## TECHNICAL BULLETIN

### NAL1407 - Vauxhall

Bulletin Ref: TB30n

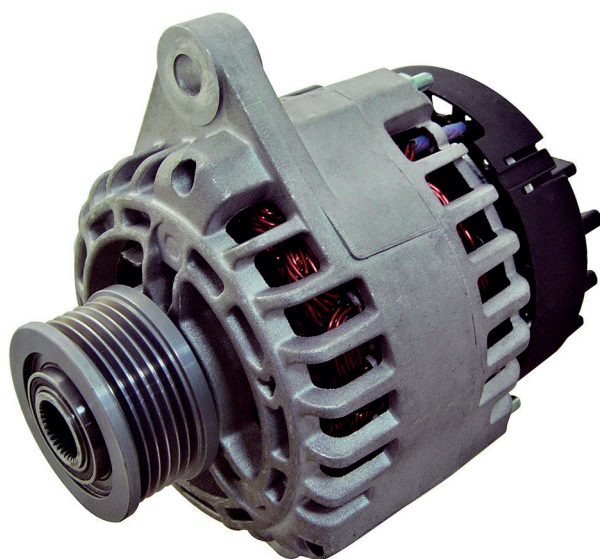
This is the earlier non 'smart charge' unit with stud fitting on the rear.

Vauxhall 1.9 CDTi models from 2007 use a 'smart charge' unit which has a 2 pin multiplug connector on the rear, these will not interchange.

Please double check before ordering.
